ALAMEDA COUNTY  
HEALTH CARE SERVICES

January 31, 2007

Subject: SLIC Case No. RO0002874, GE Imatron/Caral Manufacturing, 578 Cleveland Avenue, Albany, CA

# Attachment A: Requested Boring Locations

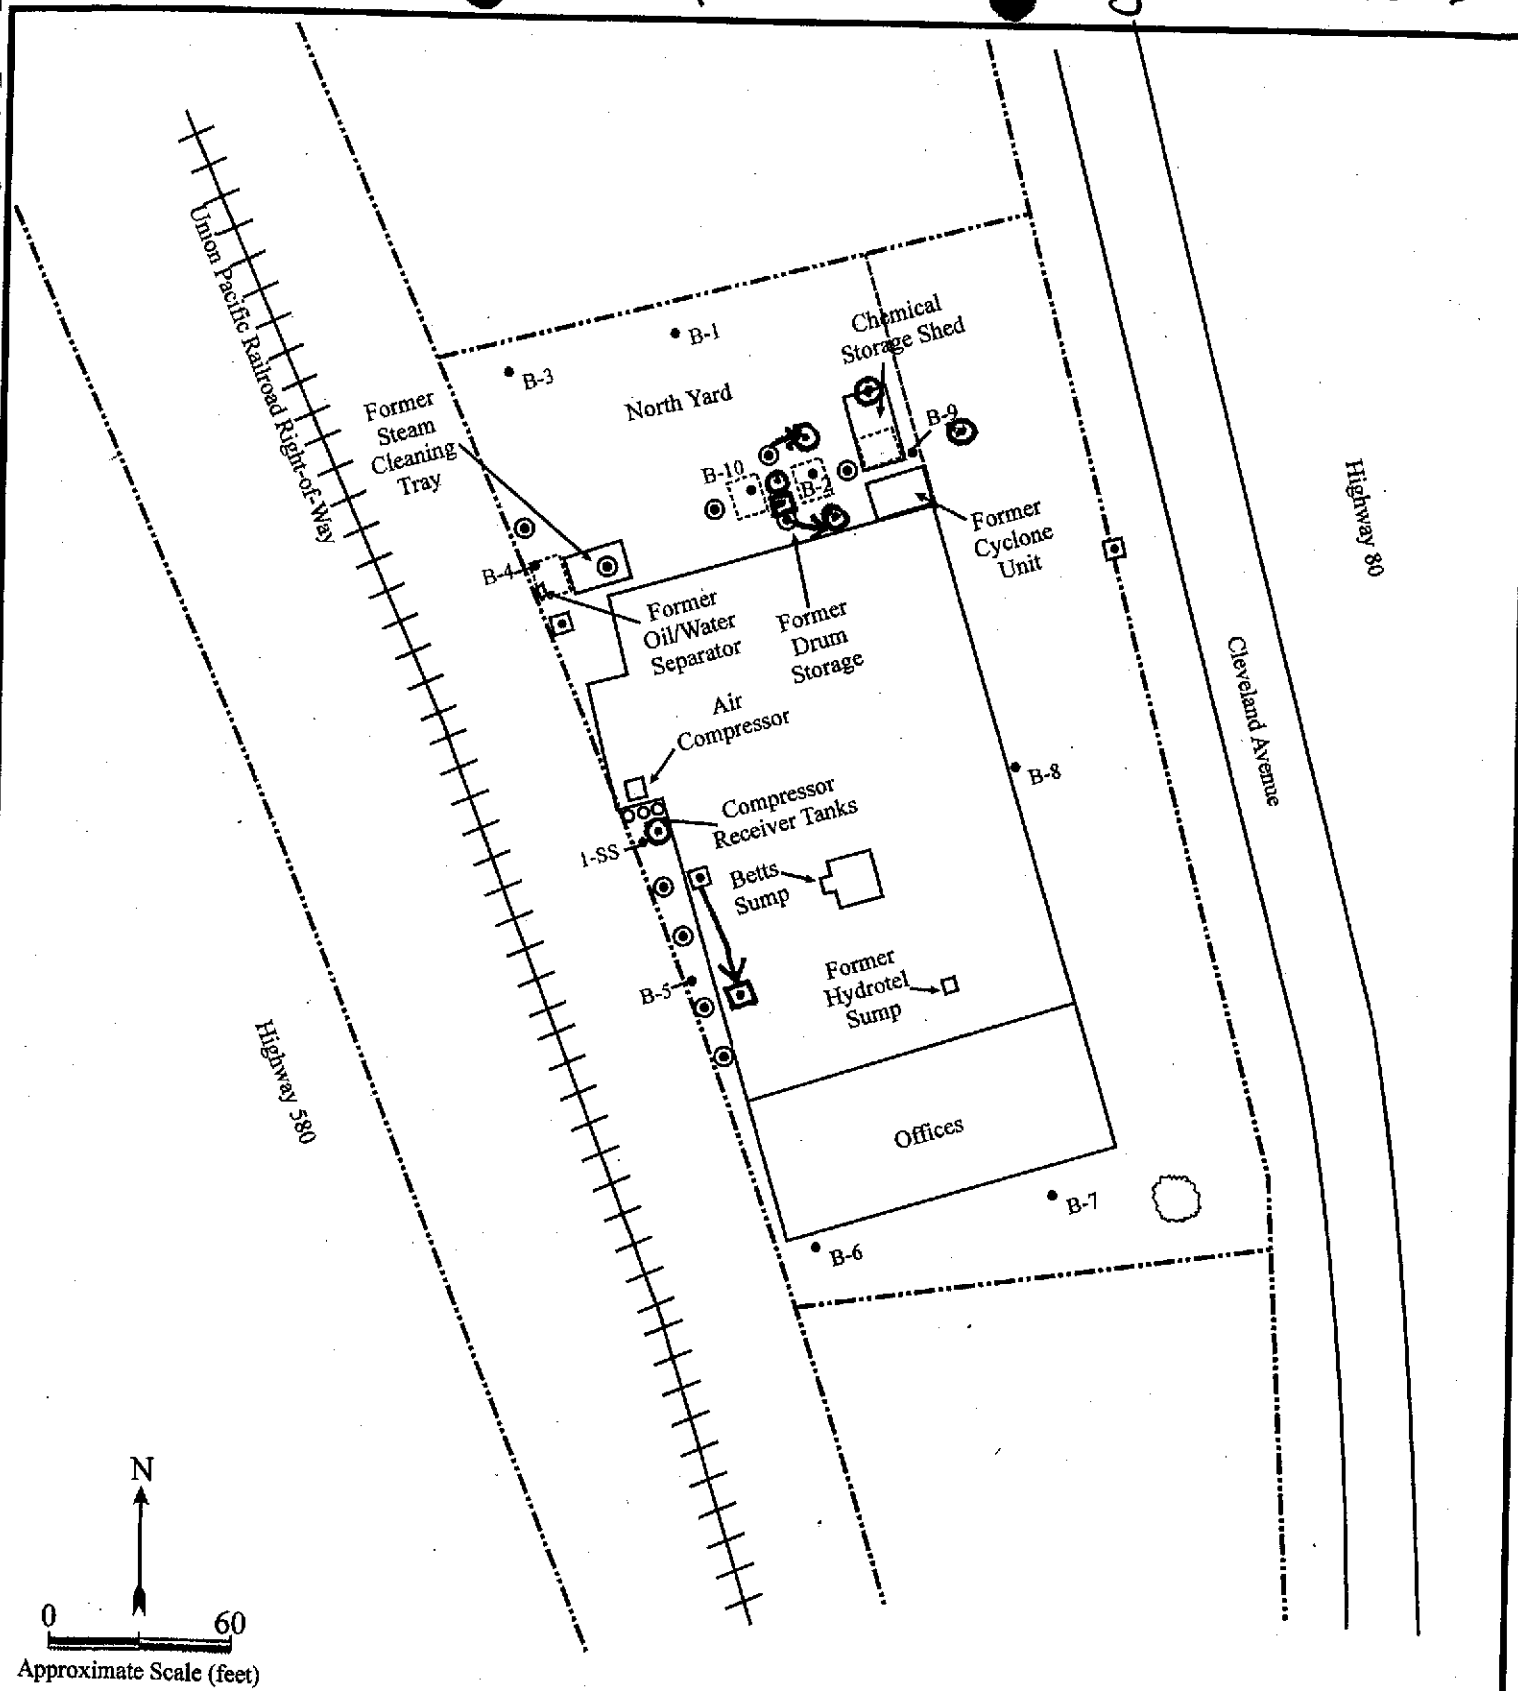
attached figure of requested boring locations. ACEH also requests that two of the proposed borings in the area of B-2 be moved as shown on the attached figure.

7. **Proposed Groundwater Sampling.** The Work plan does not describe the method for collection of grab groundwater samples. Please provide a description of the direct push sampling device or temporary sampling point that will be used to collect the grab groundwater samples. ACEH concurs with the proposed grab groundwater sampling locations and laboratory analyses but requests that one groundwater sample be collected adjacent to B-2 as shown on the attached figure showing requested boring locations. ACEH also requests that the proposed groundwater sampling location in the Area West of the Main Building be moved south as shown on the attached figure.
